Planning Commission Agenda
February 20, 2024
7:00 PM

- 1. THE MATTER OF THE PROPOSED PRELIMINARY SUBDIVISION CASTLEBERRY CROSSING AND ADJUSTMENT TO DIMENSIONAL STANDARDS LOCATED AT 930 SOMMERVILLE LOOP.**

Staff Report Harrisburg Planning Commission Harrisburg, Oregon

THE MATTER OF THE PROPOSED PRELIMINARY SUBDIVISION CASTLEBERRY CROSSING AND ADJUSTMENT TO DIMENSIONAL STANDARDS LOCATED AT 930 SOMMERVILLE LOOP.

TENTATIVE SITE PLAN

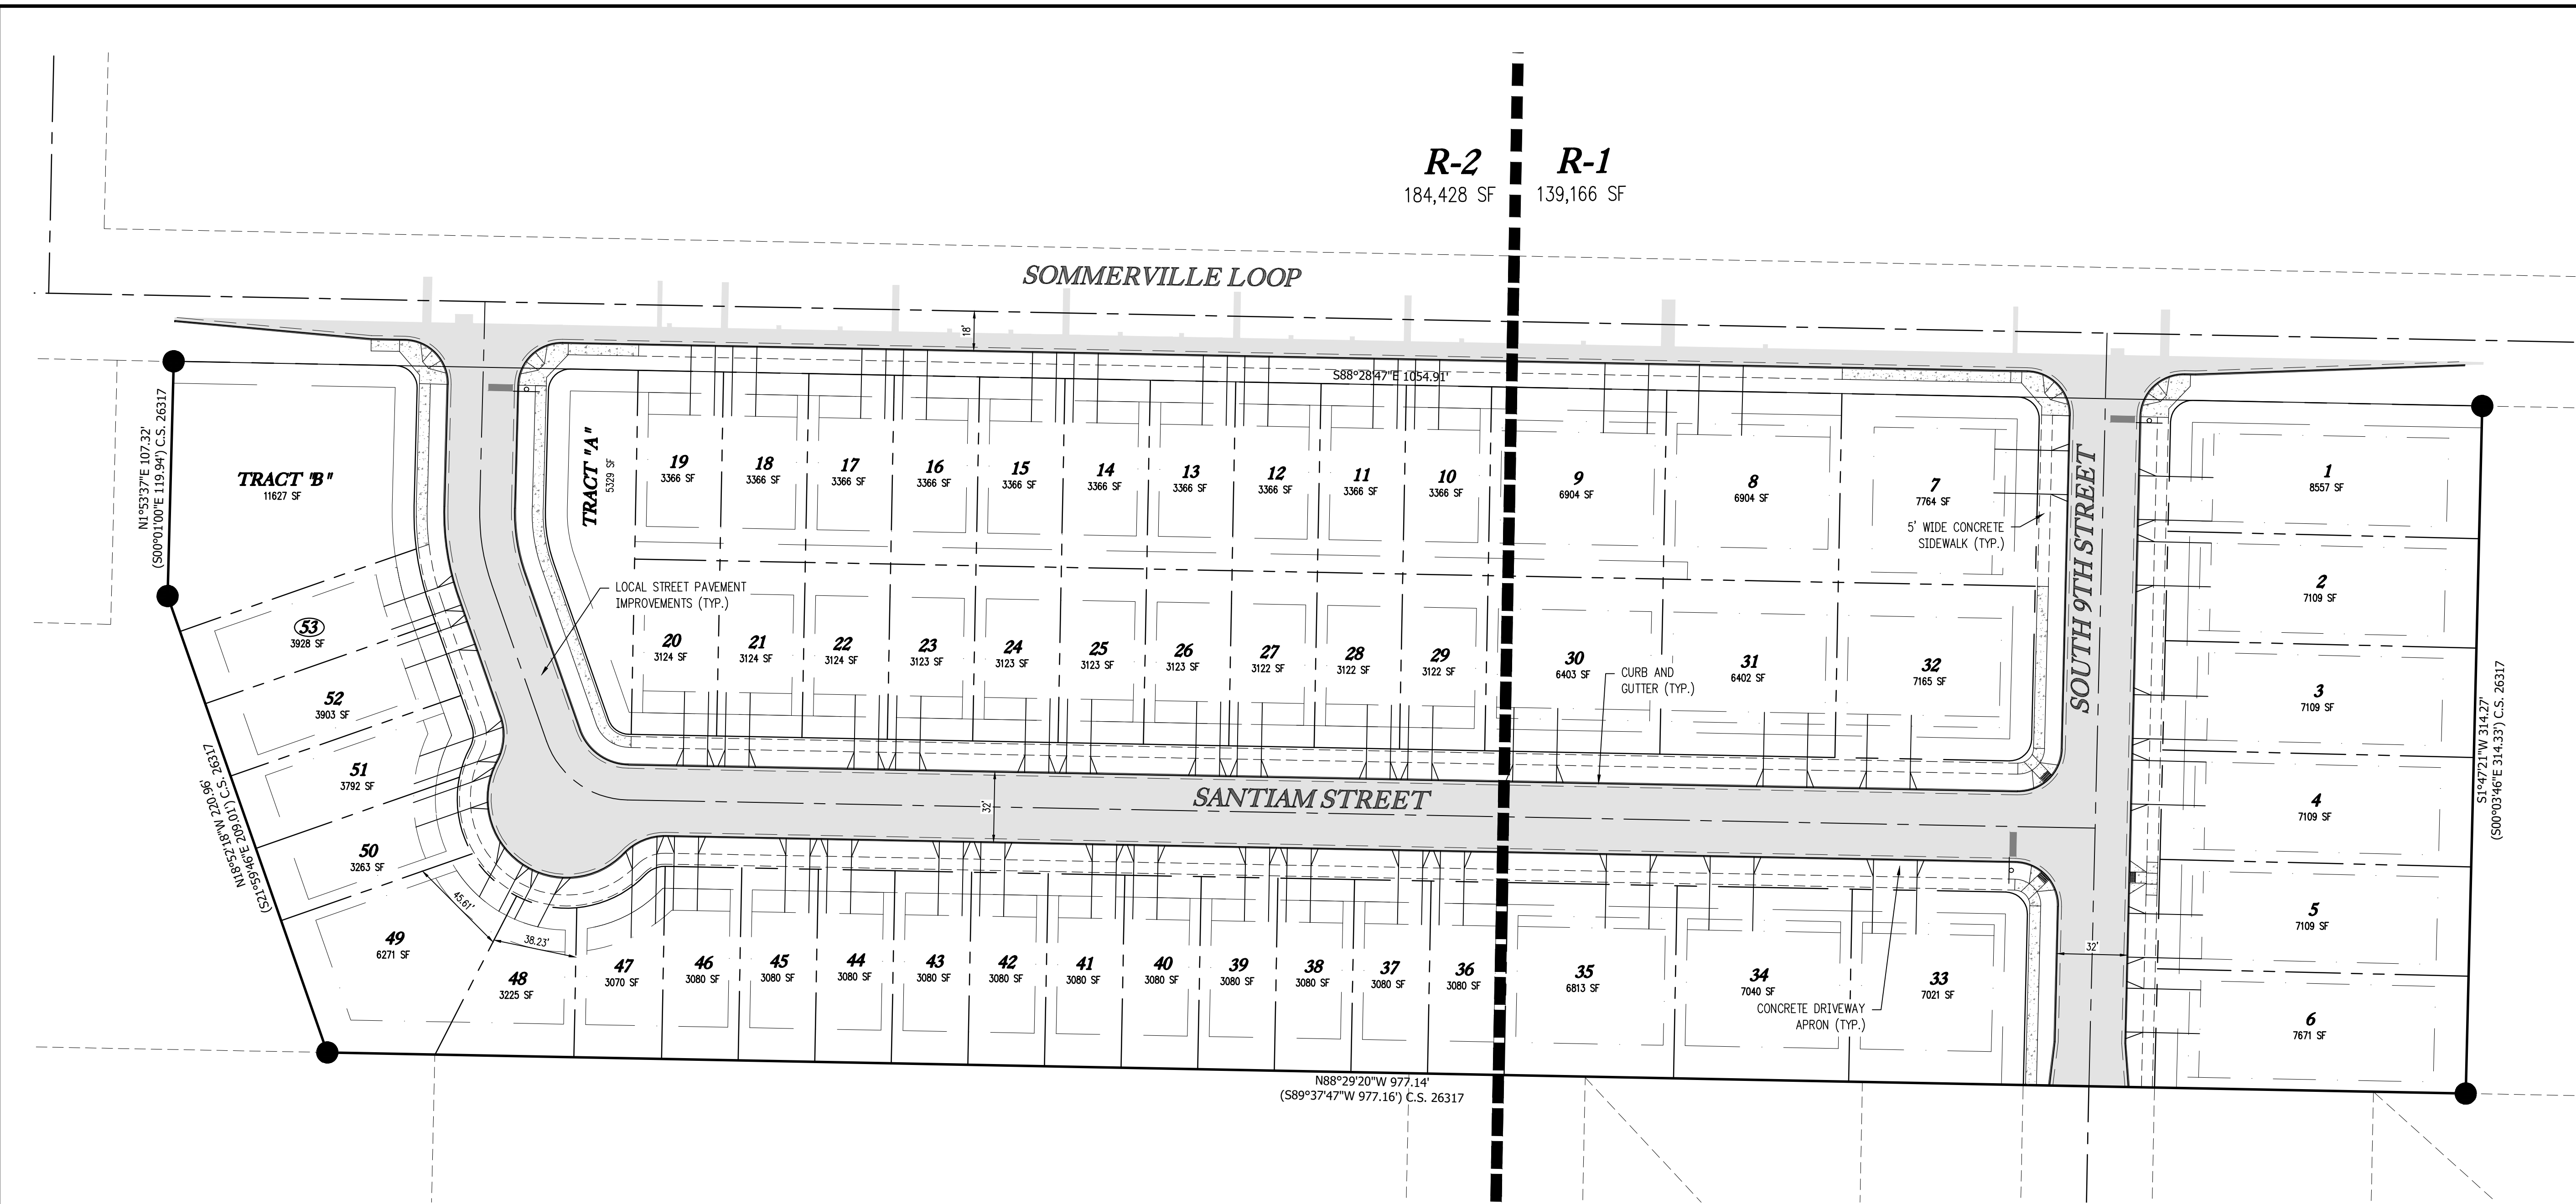
The driveway approaches on Sommerville Loop are also co-located. The co-located driveway approaches on the western R-2 zoned portion of the site do not meet the 50-foot minimum spacing standard for collector streets. The Tentative Site Plan (sheet 4 of the plan set) shows about 48-feet of spacing between co-located driveway approaches. This deficiency is also acknowledged in the Transportation Assessment memo (Exhibit G to the written narrative).

RECOMMENDED CONDITION NO. 4: At the time of Final Plat application submittal, a final site plan shall be provided that demonstrates compliance with the 50-foot minimum driveway approach spacing standard for the co-located driveway approaches on the R-2 zoned portion of the site on Sommerville Loop (HMC 18.70.030(7)).

SOMMERVILLE SAWCUT - TYPICAL SECTION

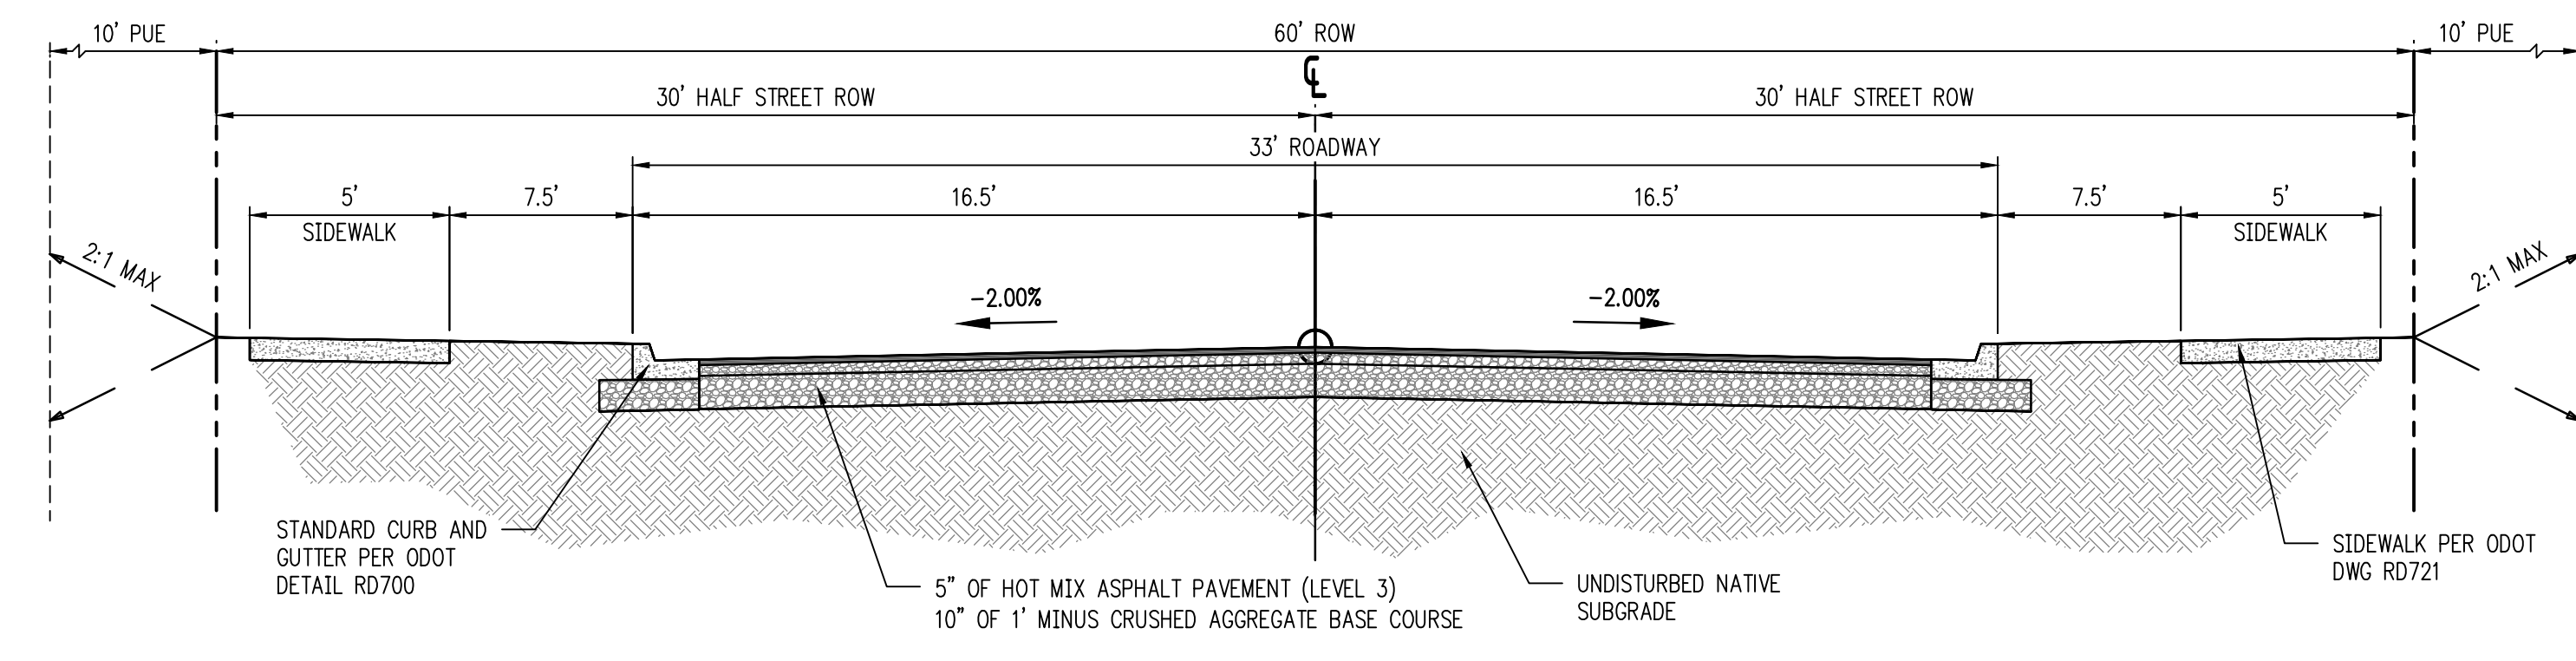
Sheet 5/8 includes a detail titled Summerville Sawcut-Typical Section. Based on Harrisburg Collector Street Standards, the Typical Section shall include the following minimum requirements from the existing paved centerline, south, and the associated necessary right of way:

TENTATIVE PLAT

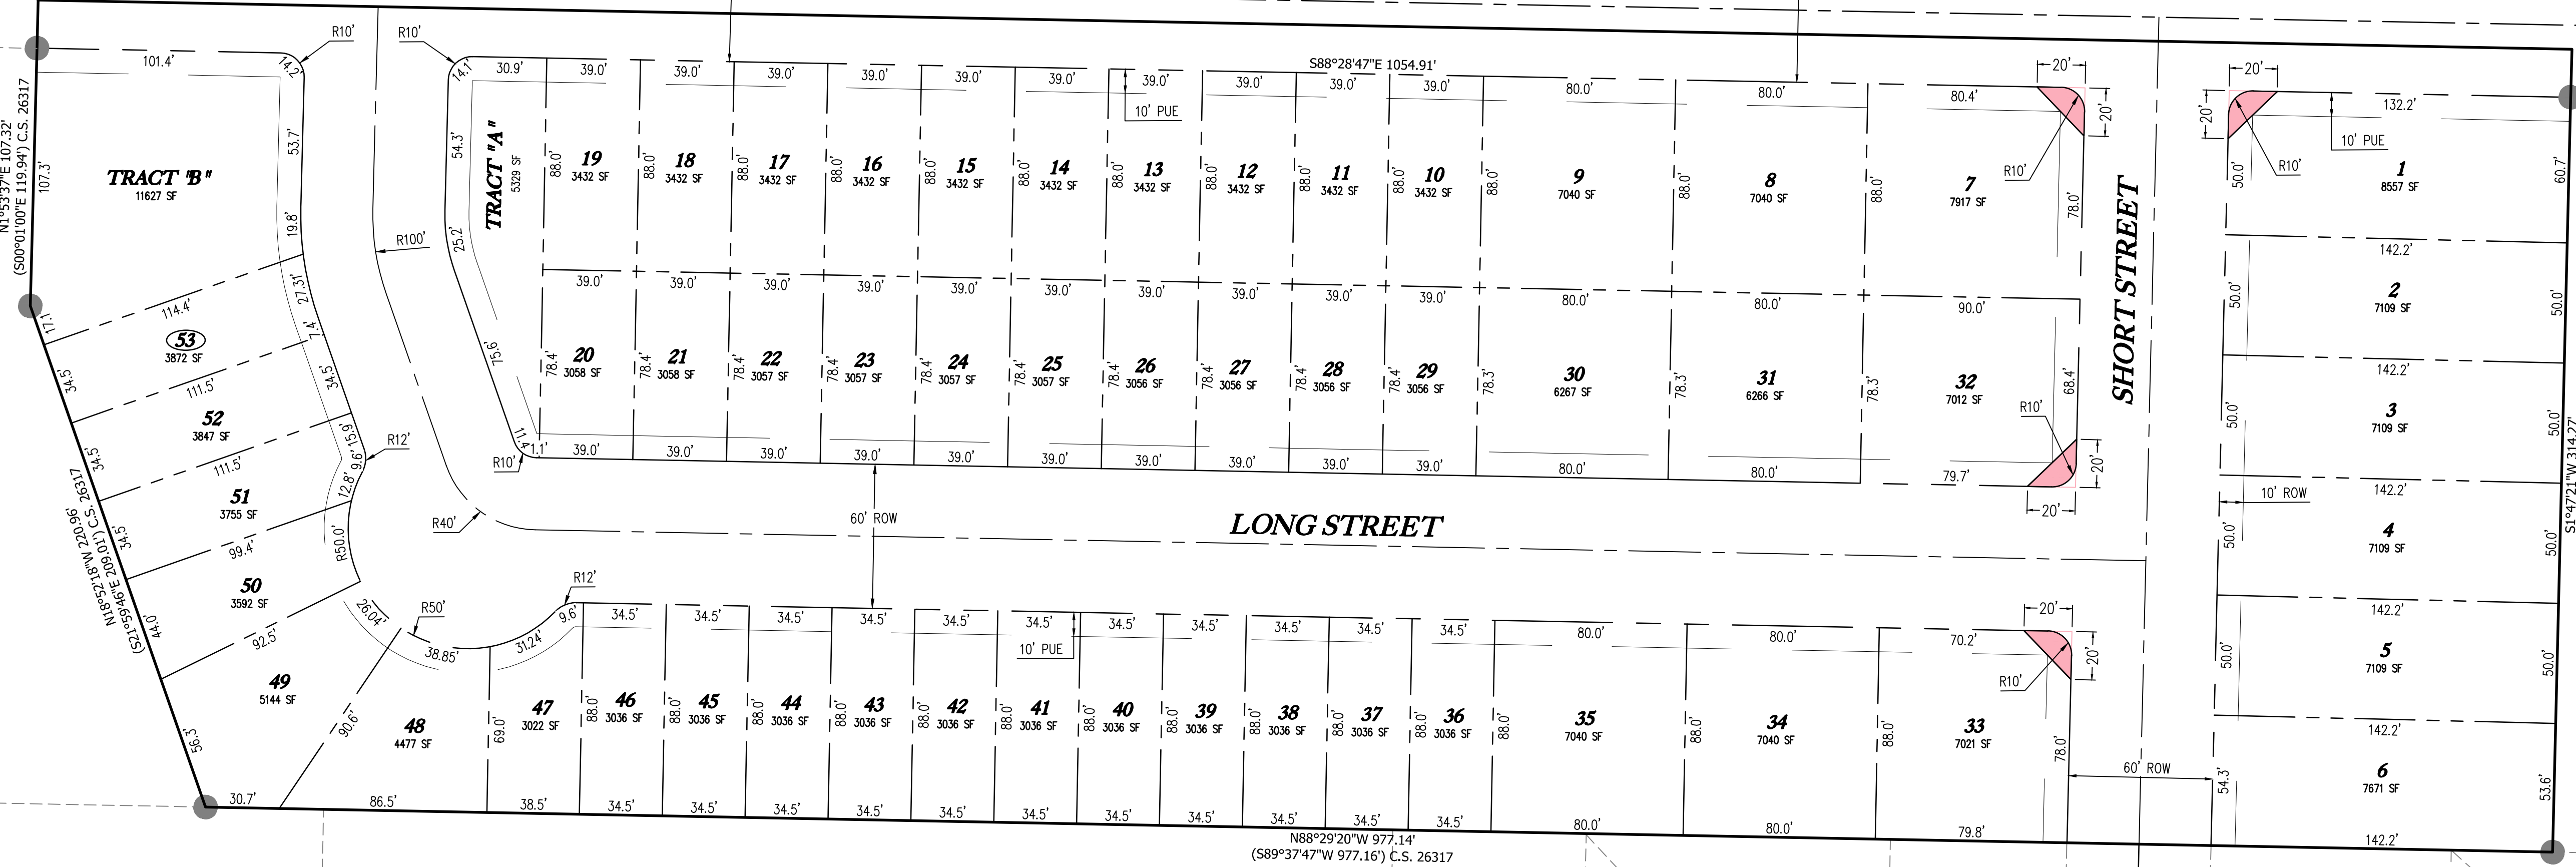
DISCUSSION: The Applicant’s vision clearance area drawing when cross referenced with the Tentative Site Plan and landscape plan, demonstrate that there are likely no proposed visual obstructions within the 20-feet by 20-feet vision clearance areas at the

three intersections of the proposed public rights-of-way. To confirm compliance with this criterion, the Applicant is required to provide a final site plan that shows vision clearance triangles on the three intersections (Sommerville Loop & South 9th Street, Somerville Loop & Santiam Street, and Santiam Street & South 9th Street) as well as both sides of the 'curve' on Santiam Street within the project area to demonstrate compliance with this criterion. If the applicant is relying on vision clearance area on private property, show an associated easement area to be recorded as part of the Final Plat application process.

RECOMMENDED CONDITION NO. 5: Provide a final site plan signed and sealed by the engineer of record that shows vision clearance triangles on the three intersections (Sommerville Loop & South 9th Street, Somerville Loop & Santiam Street, and Santiam Street & South 9th Street) as well as both sides of the 'curve' on Santiam Street within the project area to demonstrate compliance with this criterion. If the applicant is relying on vision clearance area on private property, show an associated easement area to be recorded as part of the Final Plat application process.
